BUILDING PERMIT

Job ID: 2011-08-2132-SIGN

has permission to replace 4' x 16' face in freestanding sign & install new 4'10" x 9'10" wall sign
provided that the person or persons, firm or corporation accepting this permit shall comply with all of the provisions of the Statues of Maine and of the Ordinances of the City of Portland regulating the construction, maintenance and use of the buildings and structures, and of the application on file in the department.

MILLIKEN STREET SIGNAGE

Milliken Street Sign

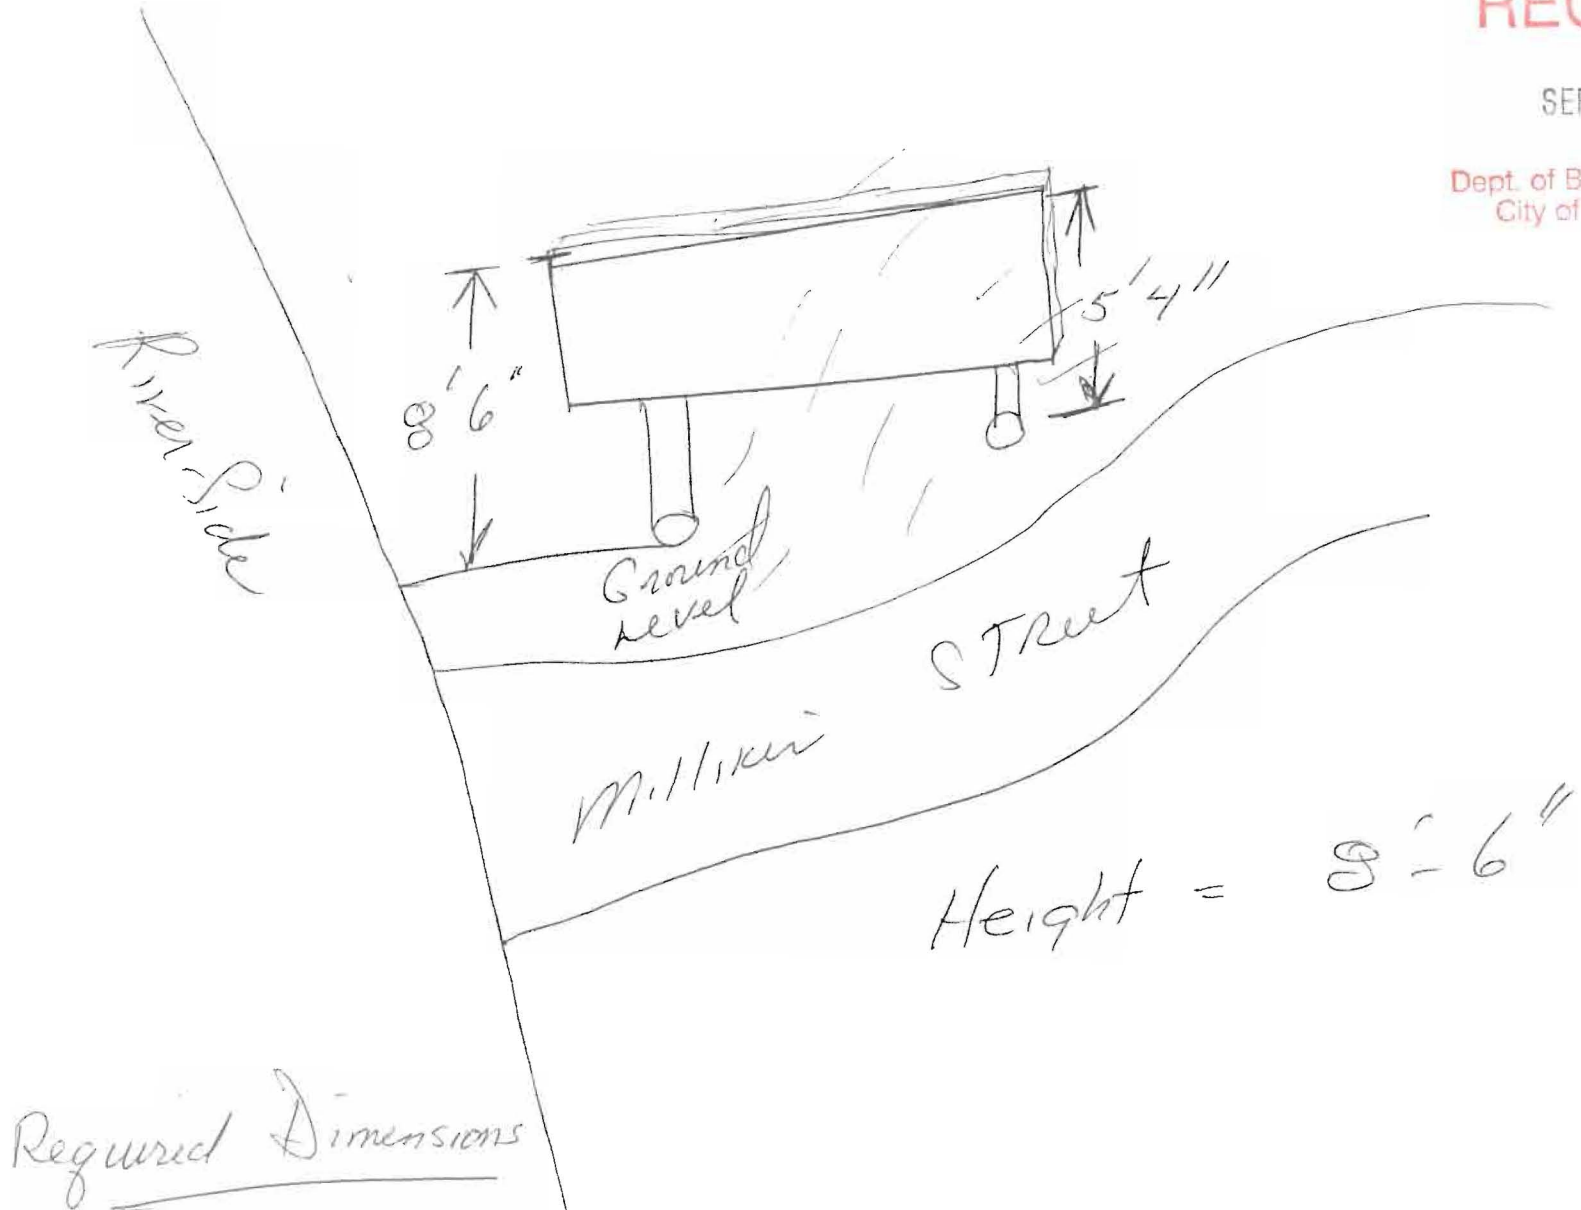
* not part of this permit
Original sign not permitted. Applicant
will either appeal the size or submit new plan
that meets the ordinance ABU

75' appeal

Wall area $170' \times 20' = 3400\text{sq ft}$ $6\% = 204\text{sq ft}$

existing = ~~16~~ ≈ 16
proposed = $32 \times 118 = 47.53$

(plan - 9/18/14)
* sign is $58'' \times 118''$
= 6844sq ft
= 47.53sq ft

1. This permit is being approved on the basis of plans submitted including the plans received 9/8/11. Any deviations shall require a separate approval before starting that work.
2. The permit is only to reface sign 'A' (4' x 16') located at the corner of Riverside Industrial Parkway and Milliken Street and to install one new 4'10" x 9'10" building sign. The second freestanding sign on Milliken Street is not part of this permit.
